Service Bulletin

Bulletin No.: PIT5012E

Subject: Antenna Mast Broken Off From Antenna Base Mount Low Profile Antenna Available

Models: 2010 - 2014 Cadillac SRX

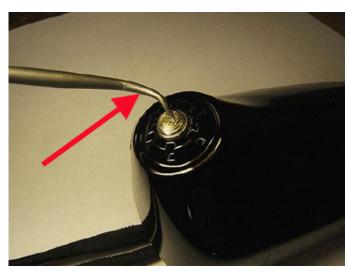
Antenna mast broken off of the roof mounted antenna base leaving the stud in the antenna base

Replace only the antenna mast. Do NOT replace the antenna base.

It is not necessary to replace the roof antenna mounting base. It was determined through review of returned parts that the broken antenna mast stud can easily be removed from the antenna base using needle-nose pliers or flat blade screwdriver or use a pick to walk the broke stud out of the antenna base.

There are two different length antenna masts available in the dealer parts catalog group 9.647, depending on your customer's needs. The original height antenna mast (280mm) and a shorter antenna mast (180mm). Note there is a slightly reduced AM and FM reception when using the shorter antenna mast.
